From: Fothergill, Anne
Sent: Tuesday, September 28, 2010 8:58 AM
To: 'CCV Permitting'
Cc: Silver, Joshua
Subject: 9 West Lenox

SUBJECT: Revision to approved HAWP (Case 35/13-07JJ), for driveway alterations, brick wall removal and brick walkway installation at 9 West Lenox Street, Chevy Chase, Chevy Chase Village Historic District

REVISED PLAN

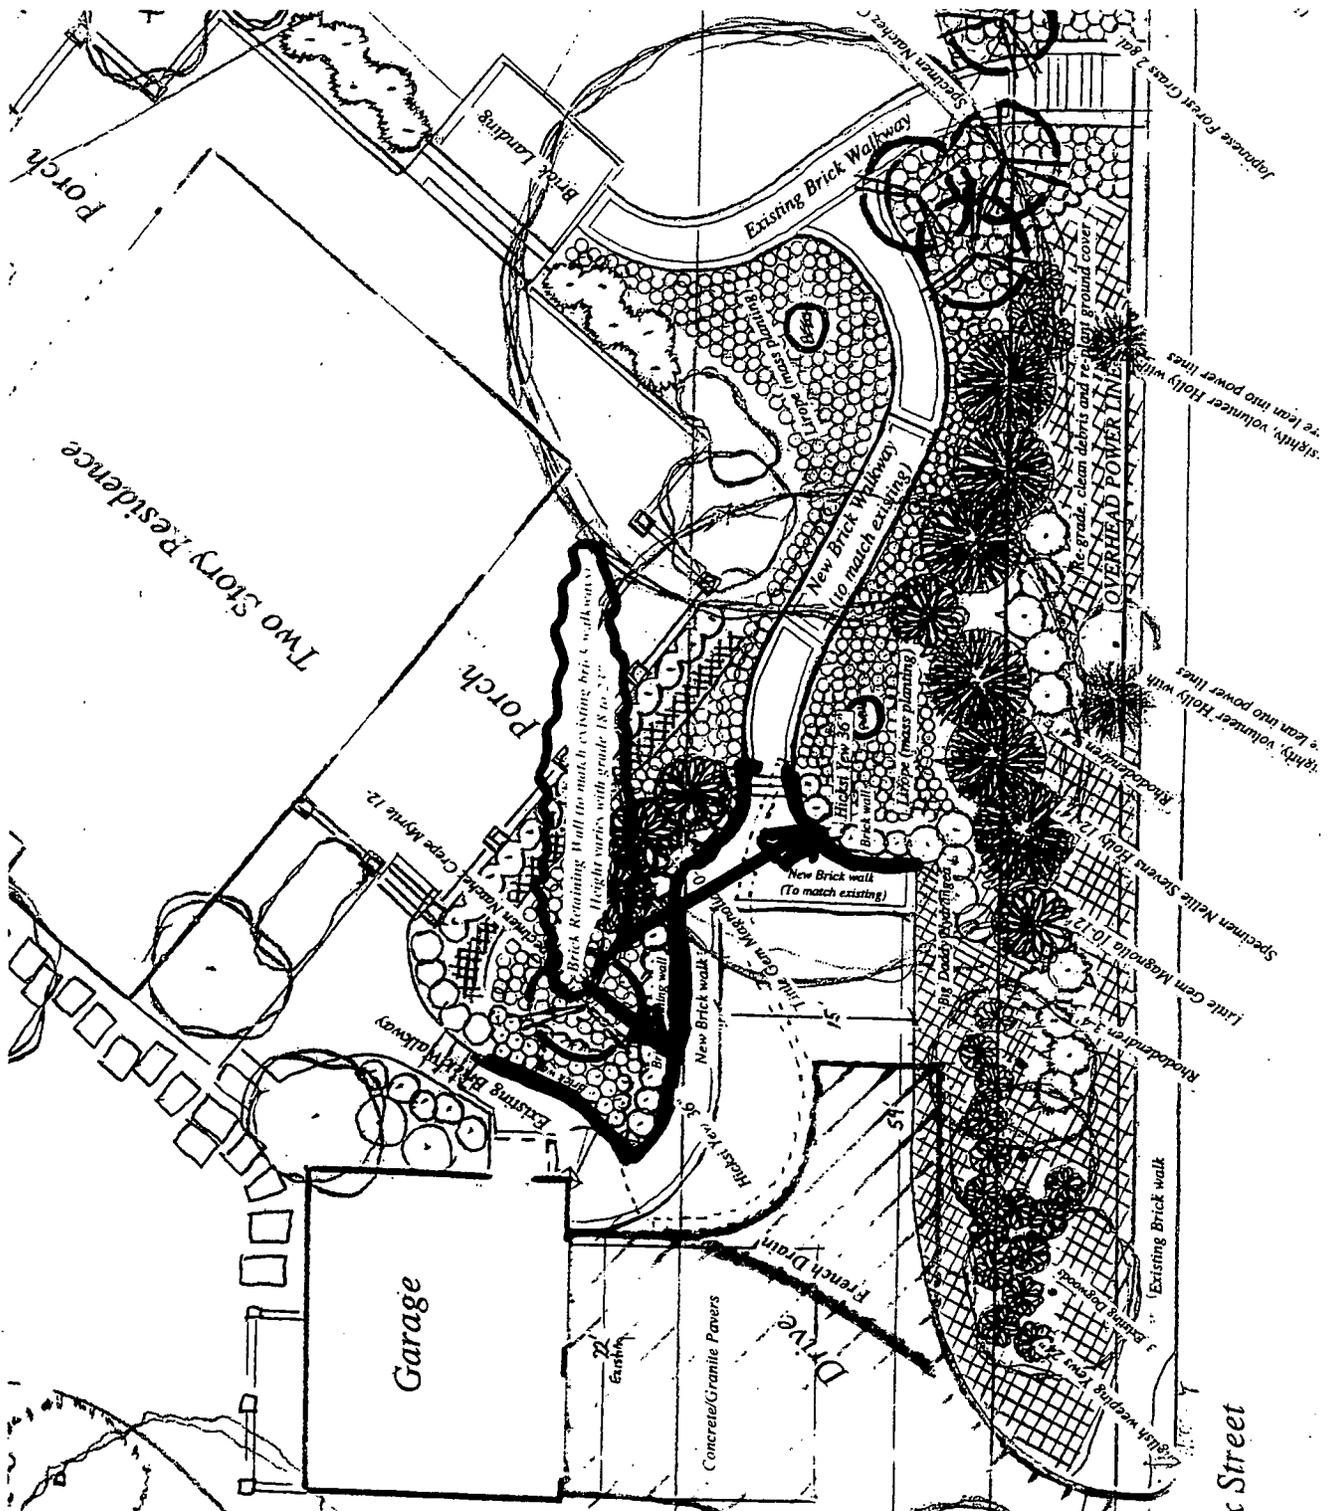
PROPOSAL: The applicant is requesting approval for the installation of an 18-23" high, brick retaining wall in the locations identified on the attached site plan. The brick will match the dimensions, texture and color of the brick approved for the walkway.

West Lenox Street
 New Brick Walkway (to match existing)
 24" deep x 6" wide French Drain filled with coarse gravel for drainage through driveway

HPC DECISION: *APPROVED*

REVISIED PLAN

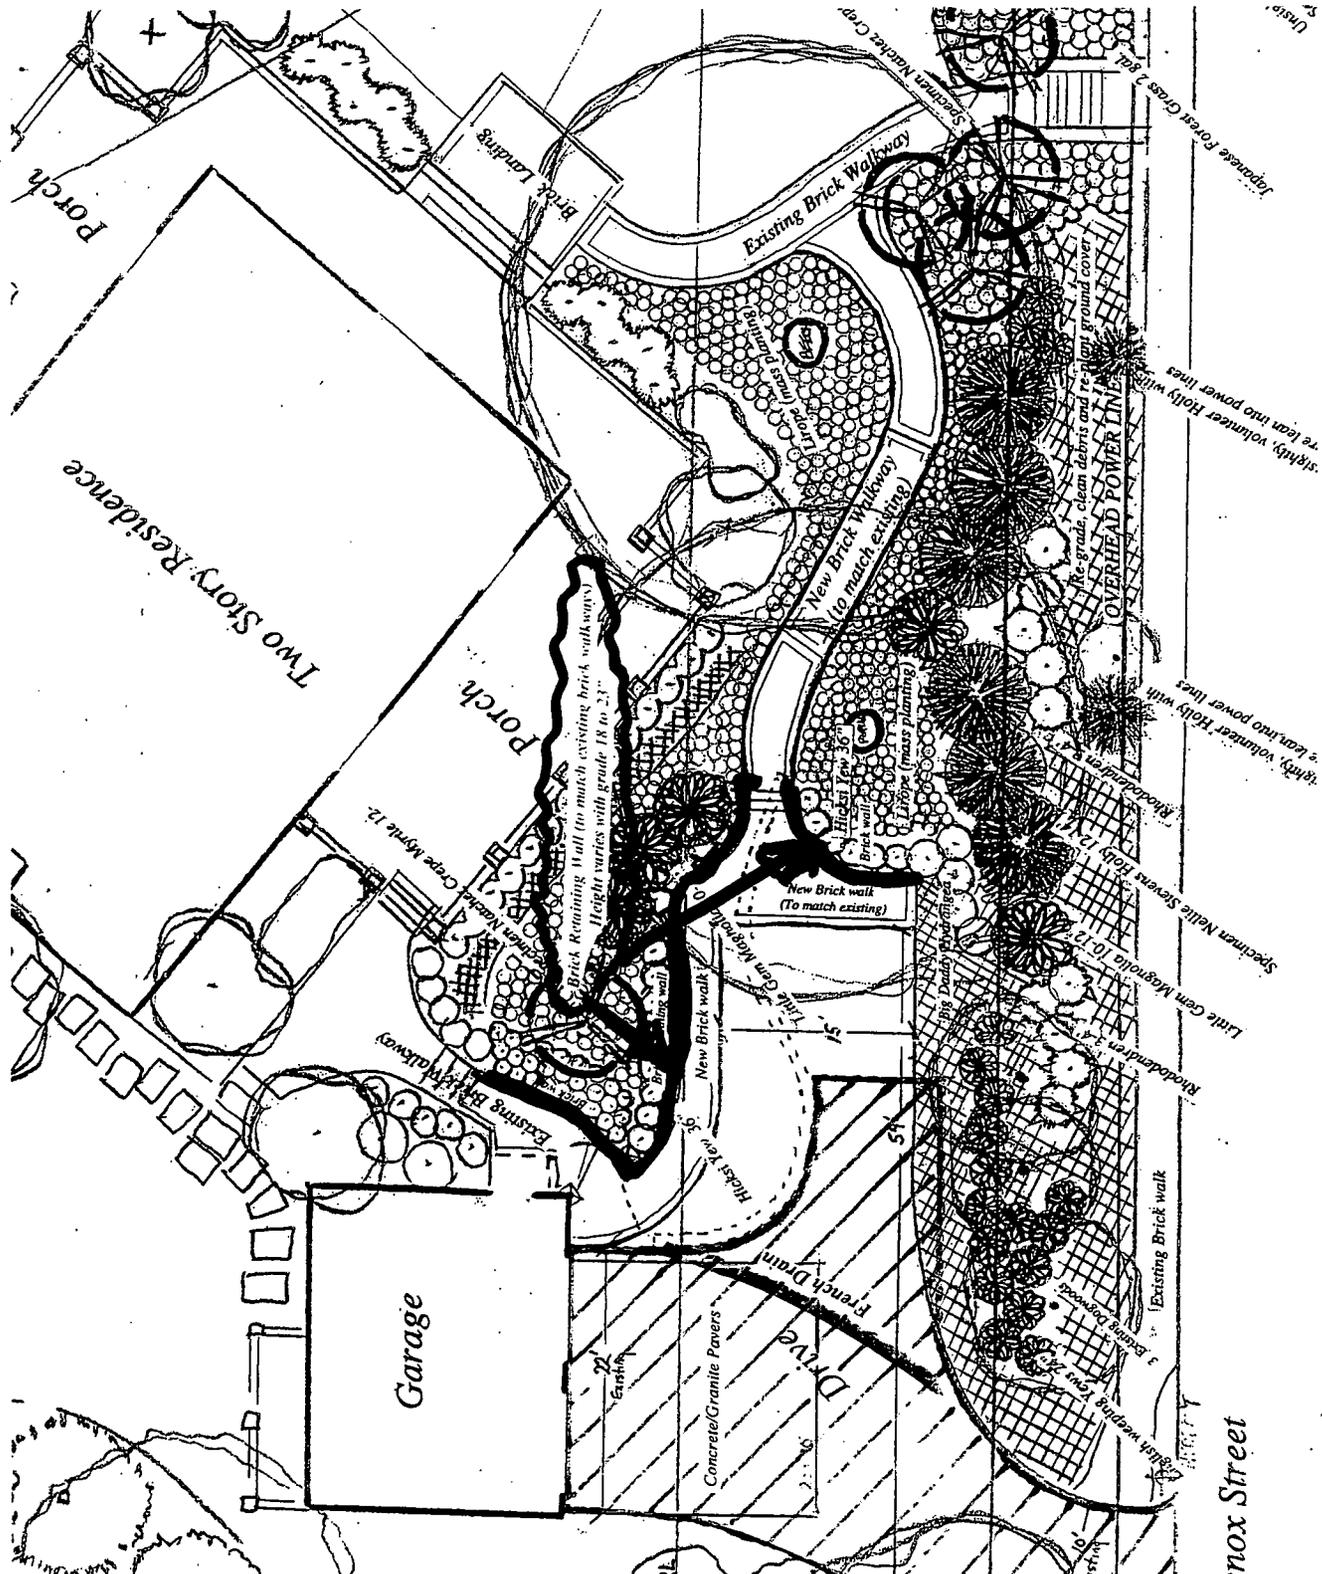
PROPOSAL: The applicant is requesting approval for the installation of an 18-23" high, brick retaining wall in the locations identified on the attached site plan. The brick will match the dimensions, texture and color of the brick approved for the walkway.

24" deep x 6" wide French Drain filled with coarse gravel for drainage through driveway

Approve A

Brick Retaining Wall
Elevation (Typical)

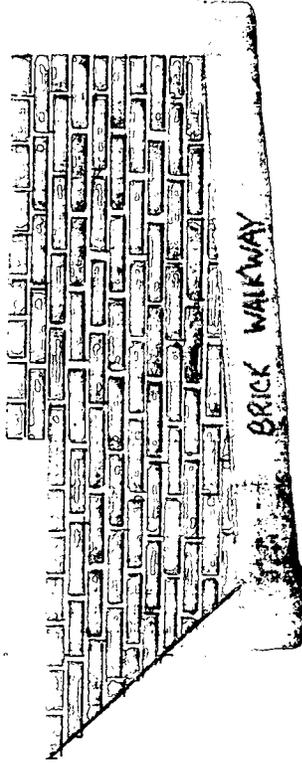
Brick retaining wall (to match brick on walkways)
Wall height varies with grade 18" to 23"

Brick retaining wall run parallel to brick herringbone walkways
